UPLAND CORPORATION-ADDITION

C1.0

SITE PLAN
SCALE: 1" = 10'-0"

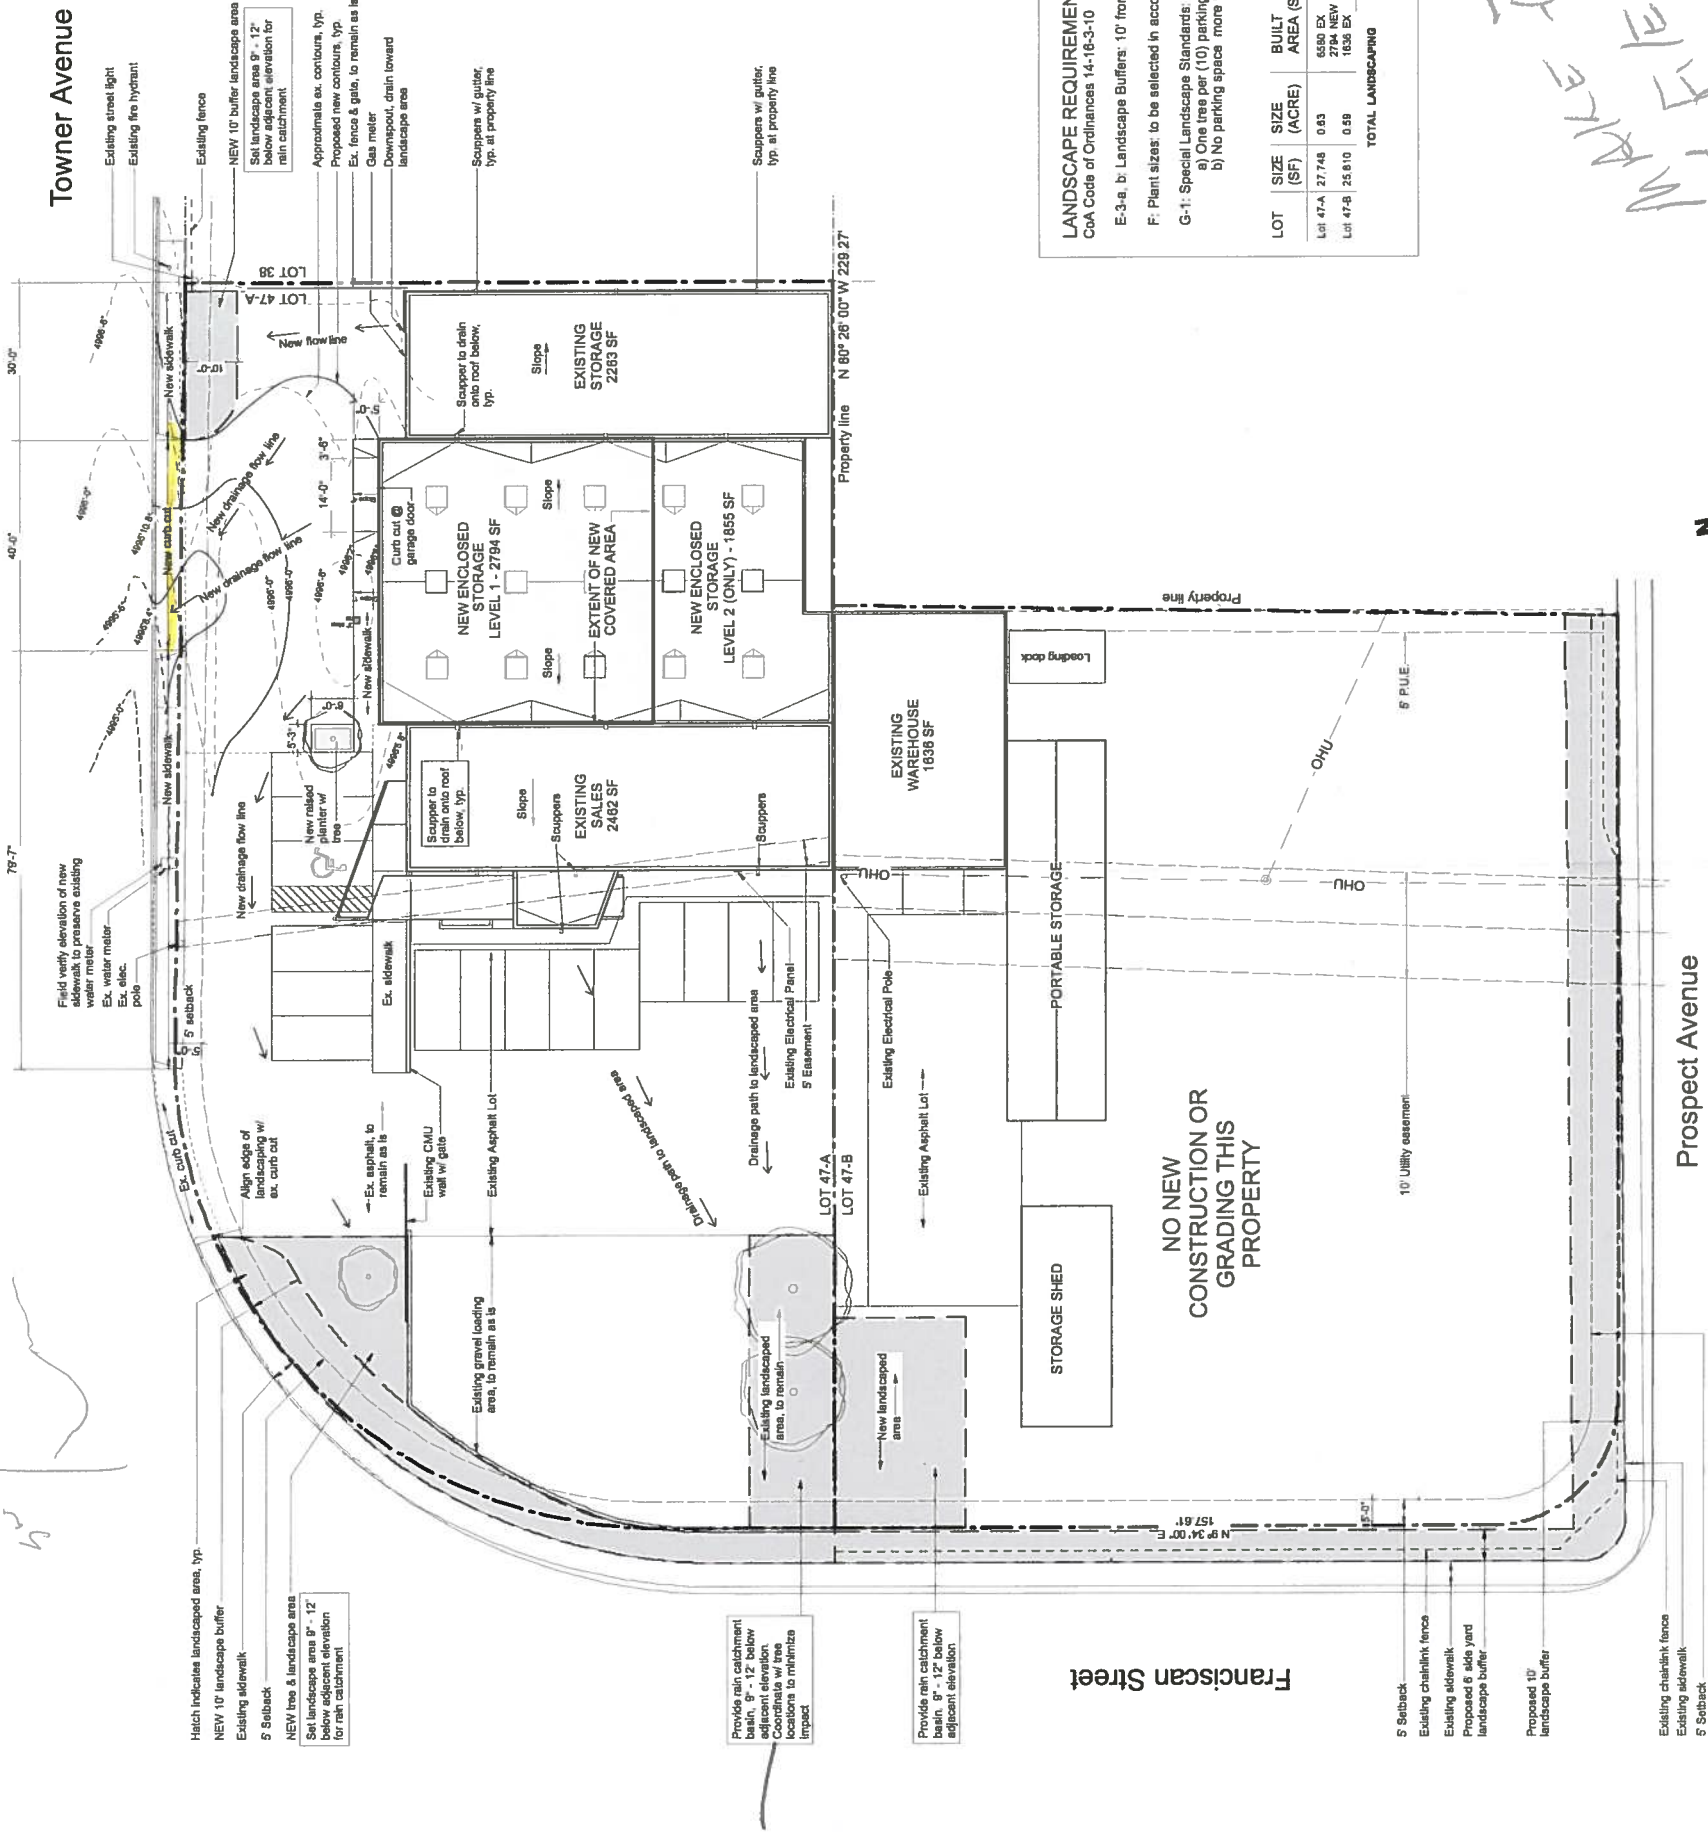
Tim/Monica
This is acceptable.
for hydrology &
approve the Bldg
permit.
Curtis Chen
5-21-17
